Staff Report to the Planning Commission

Application Number: **05-0797**

Project Description: Proposal to combine Assessor's Parcel Numbers 025-131-14 and 025-131-16, to demolish an existing 960 square foot flower shop, to construct a mixed-use structure consisting of an 2,049 square foot retail shop on the first floor, one 1,822 square foot residential unit on the second floor and residential parking at the basement level, to grade about 5,000 cubic yards of overexcavation and recompaction and 250 cubic yards of fill, to rezone the properties (parcels 025-131-14, 025-131-15 & 025-131-16) from the C-4 zone district to the C-2 zone district, and to amend the General Plan land use designations for the three parcels from Service Commercial (C-S) to Community Commercial (C-C).

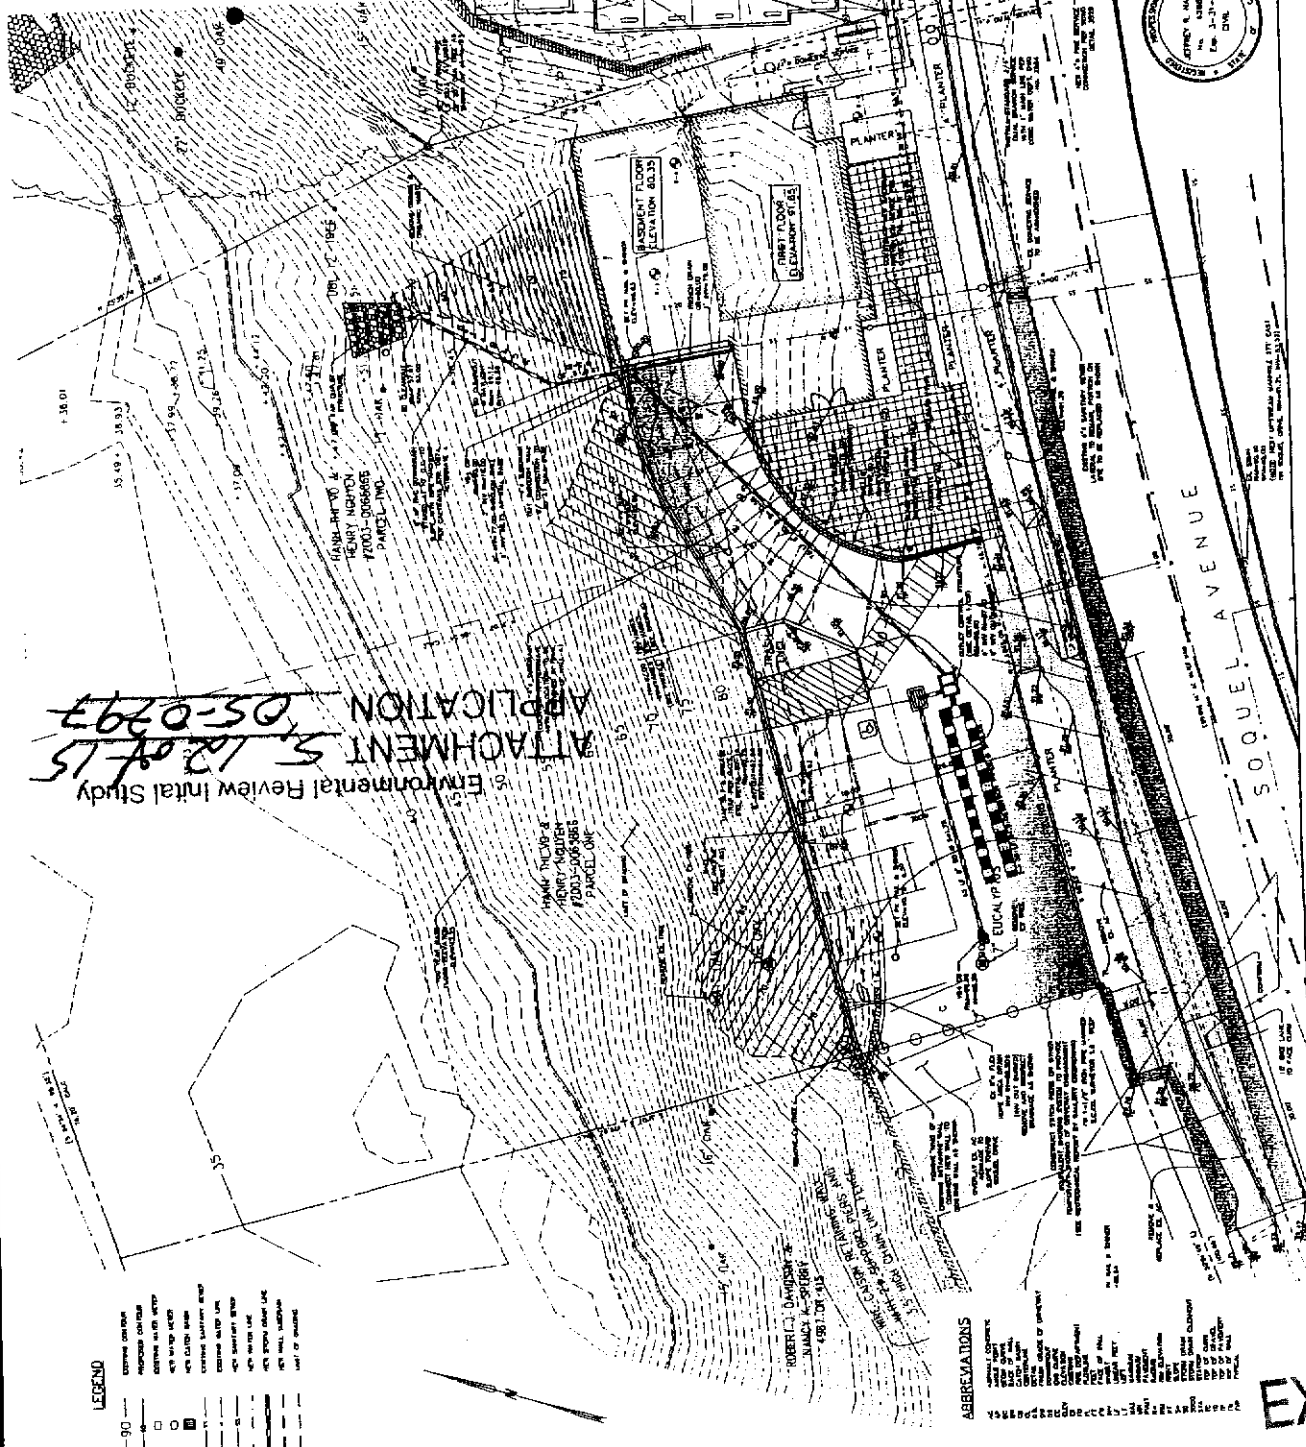
1. Revise plan sheet C-2 to include top of wall and bottom of wall elevations for all proposed walls.
2. Extend all x-sections on sheet C2 to Arana Gulch

3. Add a x-section on sheet C-2 that runs from Soquel Ave to Arana Gulch that passes through the building.
4. X-sections A-A and B-B on sheet C3 show fill being placed on the downslope side of the retaining wall. Per the soils report, this fill should be keyed and benched into the bedrock layer. Another option may be to leave the lower bench and daylight the bench to the -67' contour.

6. Include the base flood elevation on sheet C-2 and also on the x-sections on sheet c-3.
7. The drainage dissipator is located in the creek channel below the base flood elevation. Provide information as to what the dissipator is to be constructed of and how it will remain in place during high flows. Additionally, Bauldry Engineering will need to sign off on the location of the drainage outlet as a stable location that will not affect slope stability.
